ADDENDUM NO. 1

**TITLE: BOONE CENTRAL POST TENSION TRACK AND FOOTBALL FIELD PROJECT
BOONE CENTRAL PUBLIC SCHOOLS**

PROJECT: REGA NO. 121271

DATE OF ISSUE: March 22, 2013

DEMOLITION PLAN

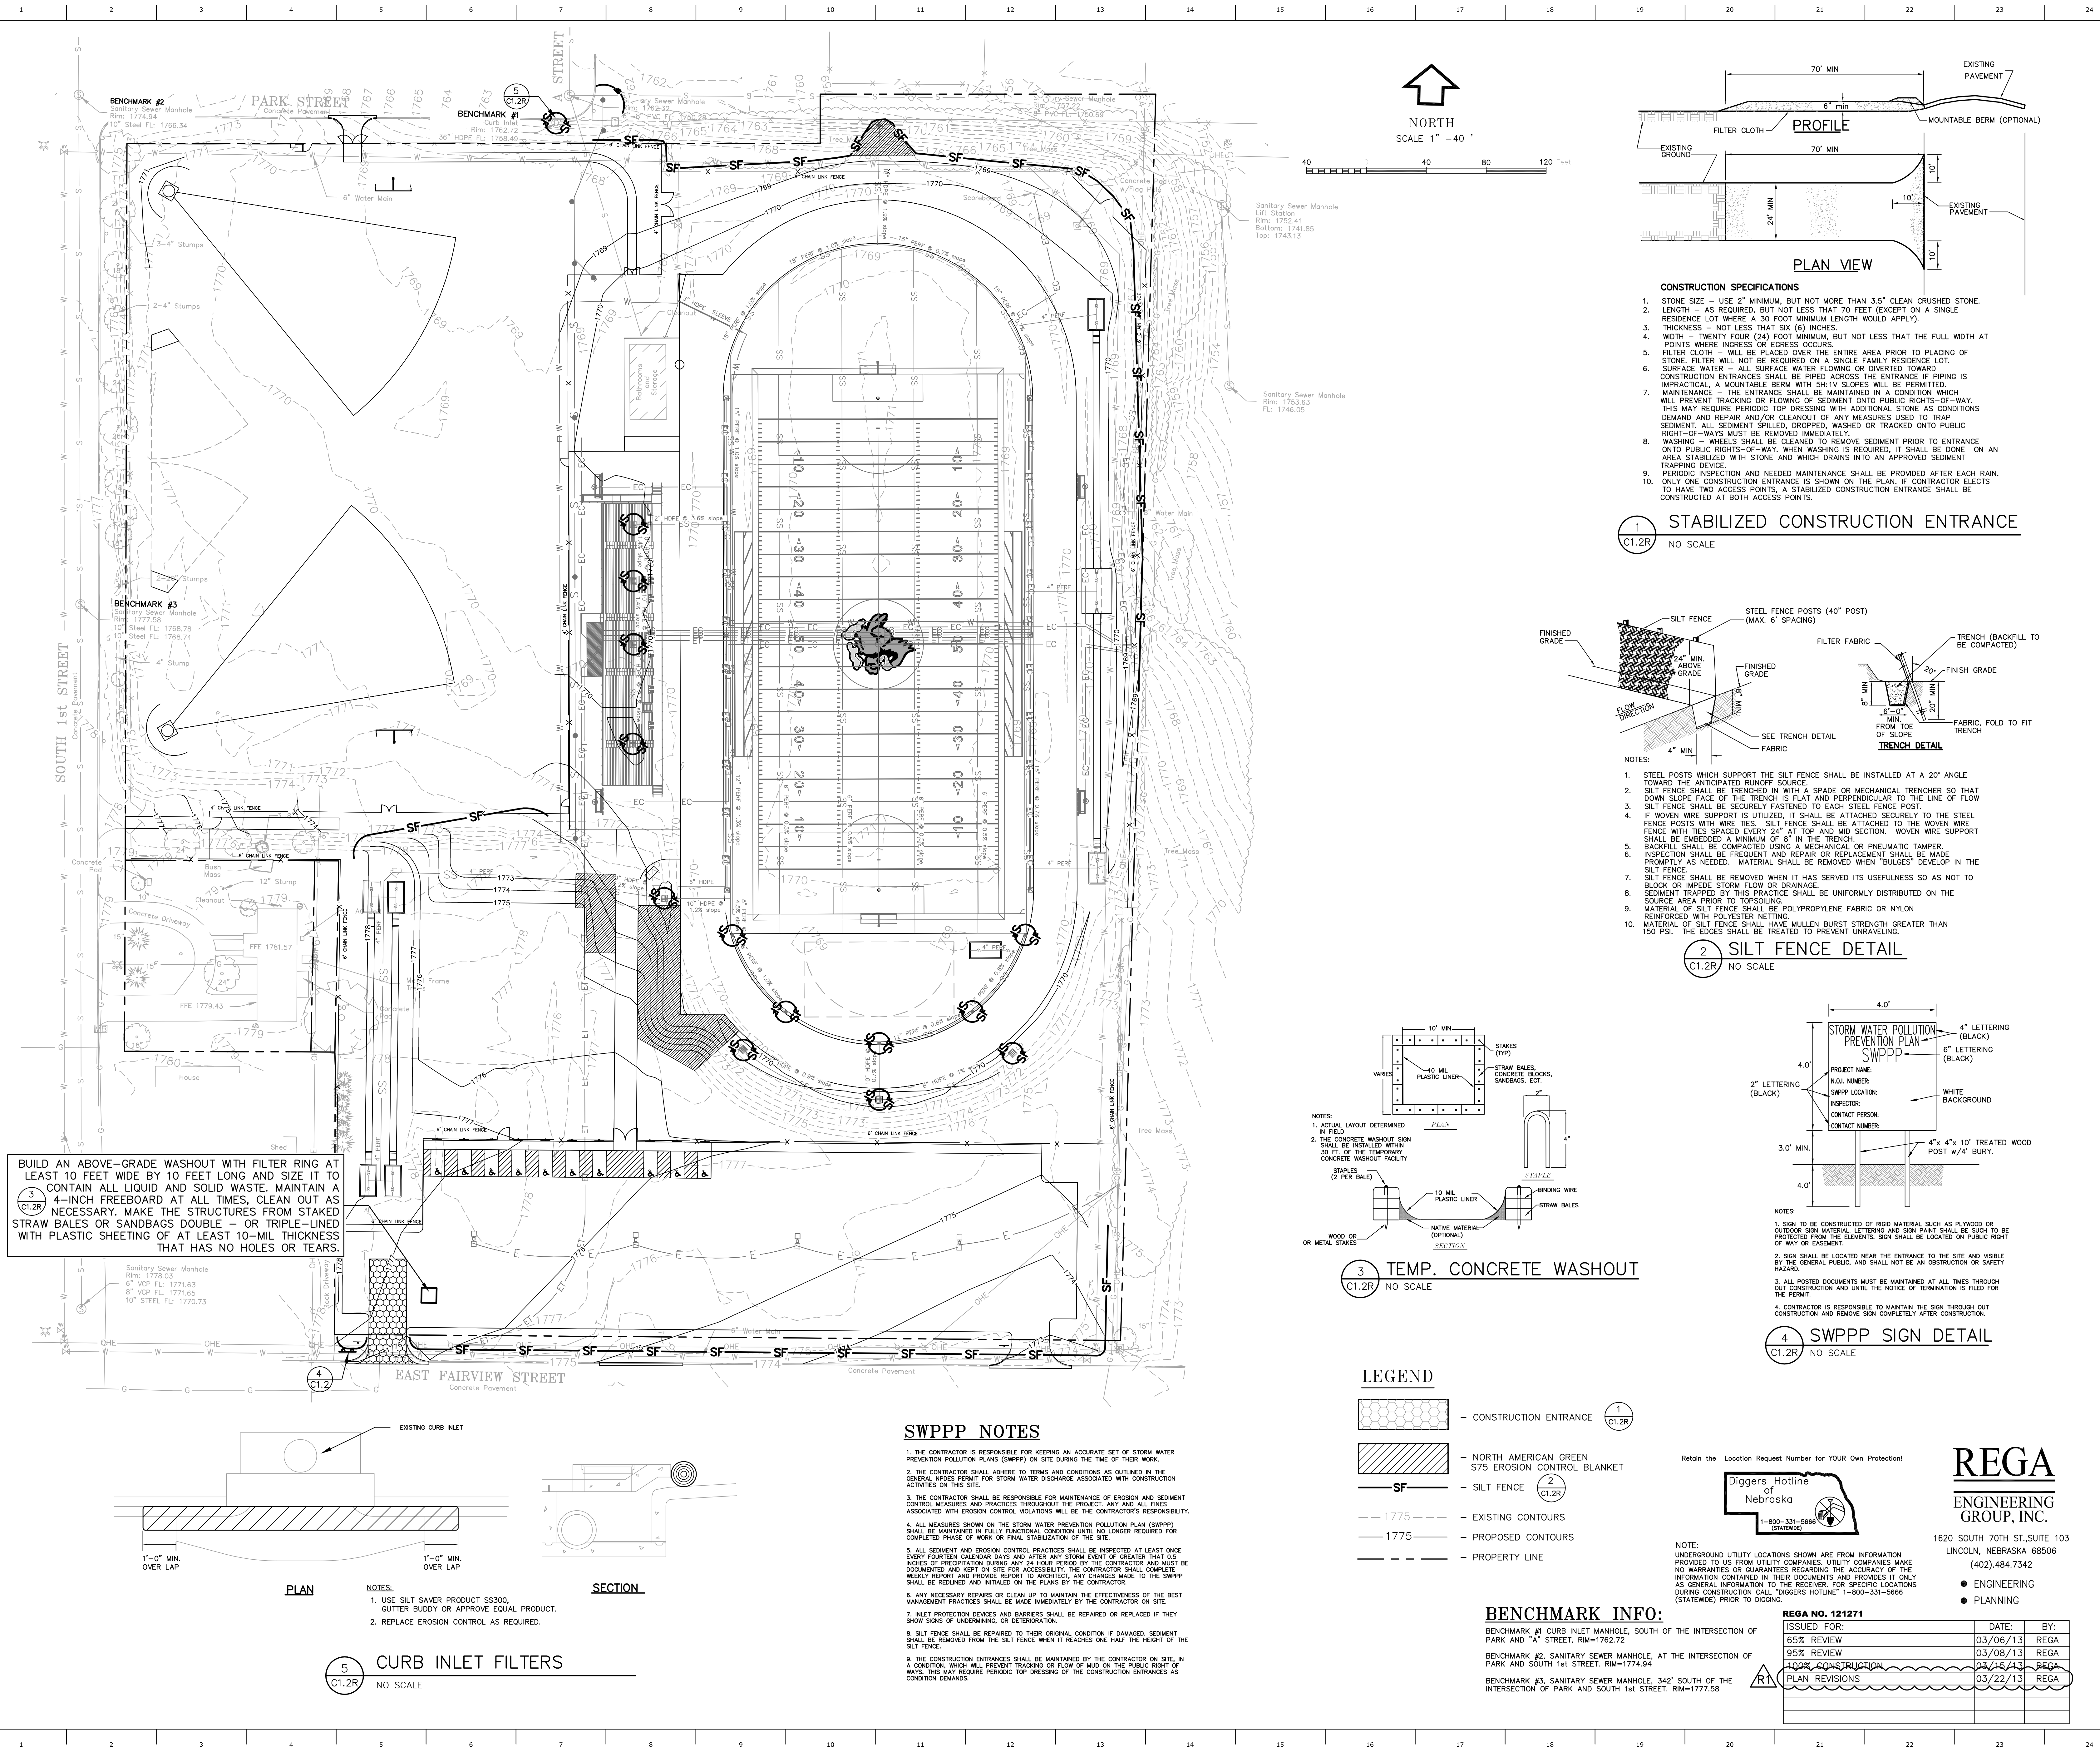
Revise: Removal information notes 2, 7, 11

Delete: Removal information note 5

Revise: Limits of tree removal on the north and northeast side of the project

Delete: Remove gates

Add: Removed gates and salvage for re-use by owner near scoreboard. See Sheet C1.4R for additional information

Delete: Protect garage

Add: Remove garage, concrete slab, and foundation complete

Delete: Remove shed, concrete slab, and foundation complete

Add: Owner shall remove shed, contractor shall remove concrete slab and foundation complete.

Delete: Contractor shall remove and salvage existing memorial sign see layout sheet C1.4 for further information.

Add: Owner shall remove existing memorial sign. Contractor shall remove foundation.

Delete: Contractor shall remove existing bleachers, concrete pads, and all utilities complete.

Delete: Contractor shall remove existing press box, foundation, and all utilities complete.

Add: Owner to remove bleachers and press box. Contractor shall remove existing foundation and all utilities complete.

Add: Gate to be removed and replaced, see C1.4R.

**4" CONCRETE PAVEMENT w/JOINT DETAILS
 (5" CONCRETE PAVEMENT w/JOINT
 DETAILS, ALTERNATE BID)**

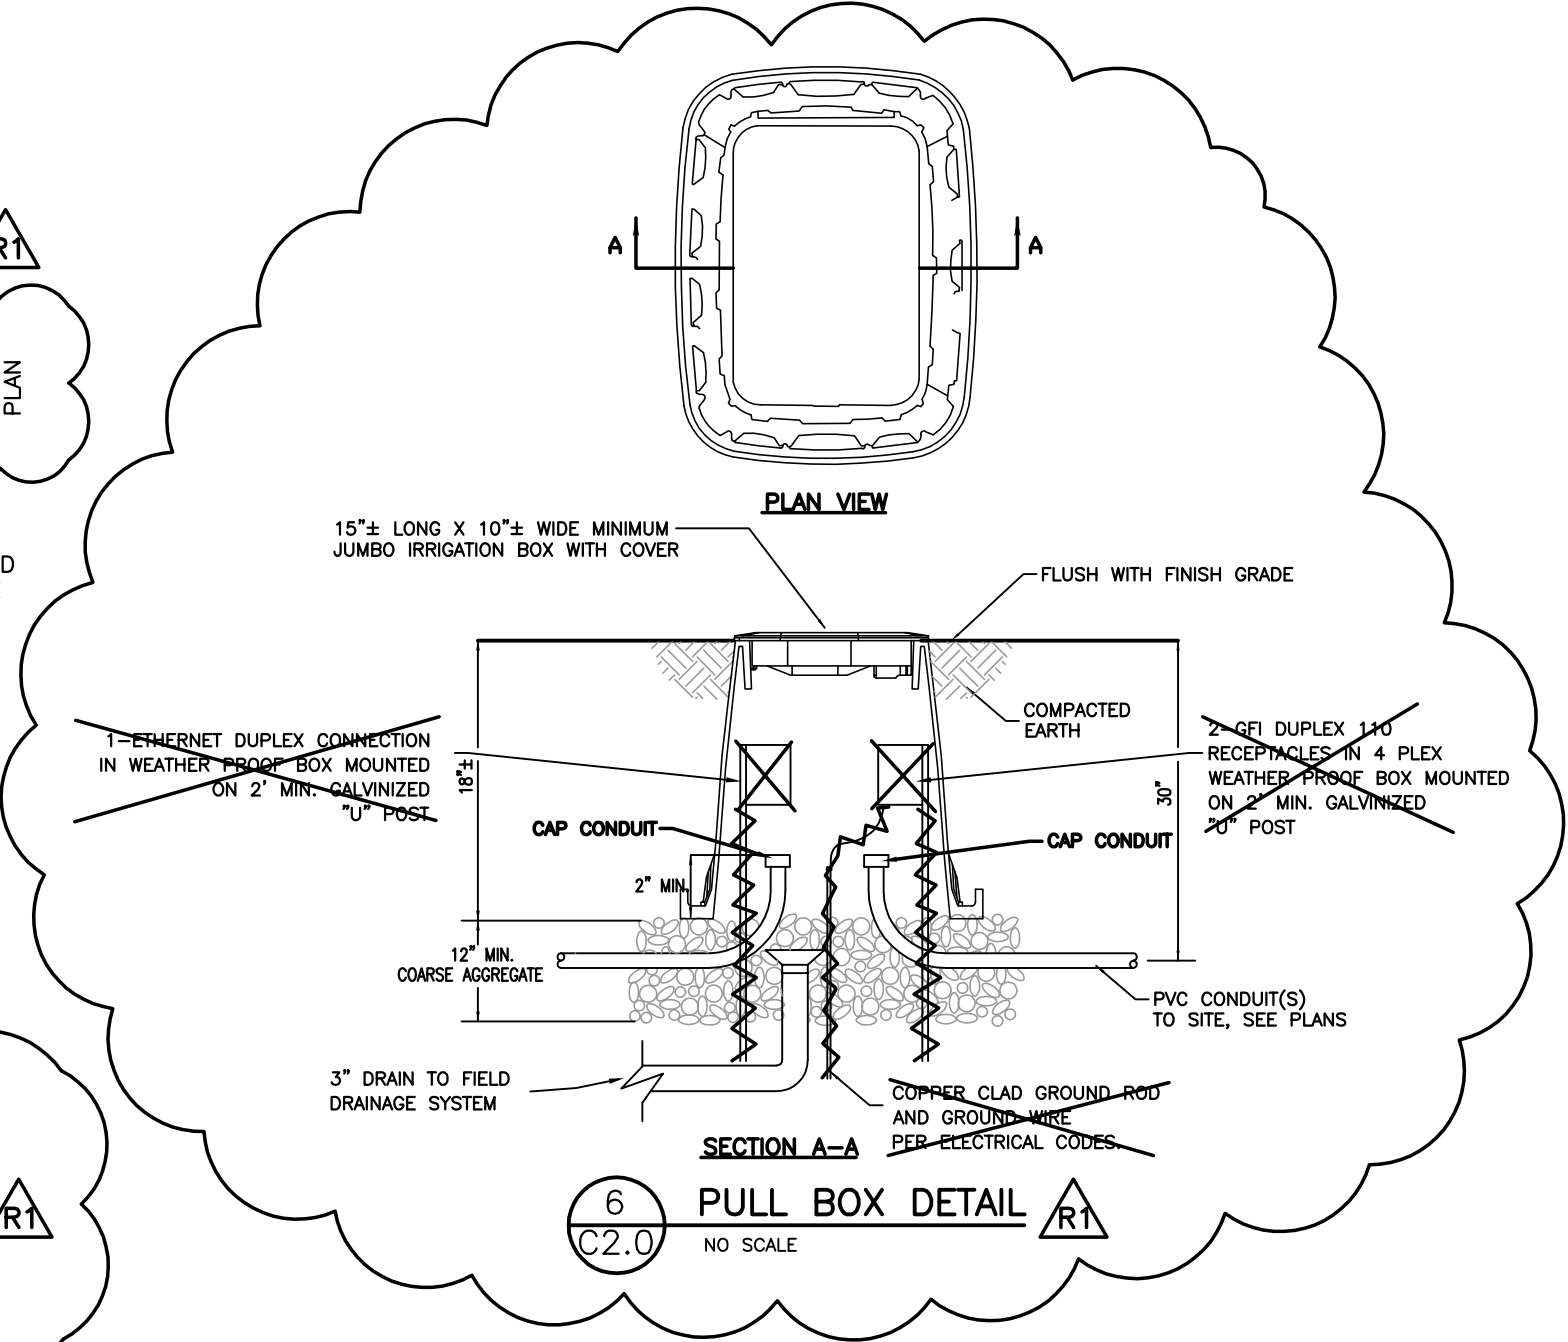
Revise: Details 5 and 6

ISSUED FOR:	DATE:	BY:
DETAIL 5/C2.0, REVISED TITLE AND OVERALL PAVMENT DIMENSION.	03/22/13	SDB
DETAIL 6/C2.0, REMOVED GFI OUTLETS MOUNTED ON "U" POSTS, REMOVED ETHERNET OUTLETS MOUNTED ON "U" POSTS, REMOVED COPPER GROUND ROD, CAPPED BOTH CONDUITS.	03/22/13	SDB

REF. SHT# C2.0

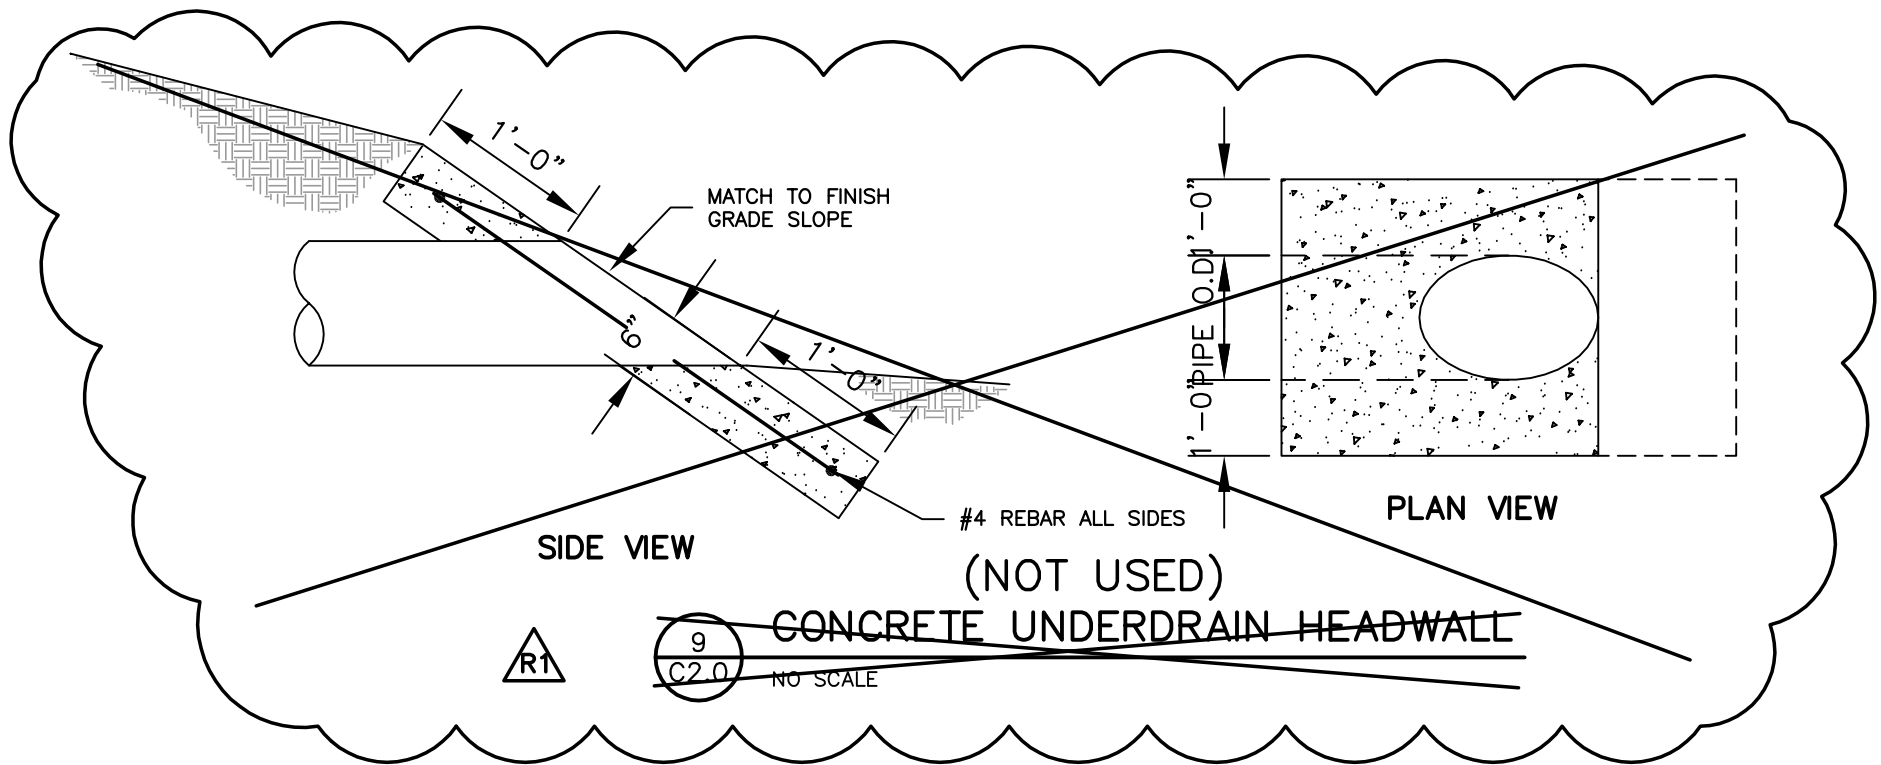
Delete: Detail 9

ISSUED FOR:	DATE:	BY:
DETAIL 9/C2.0, NOT USED	03/22/13	SDB
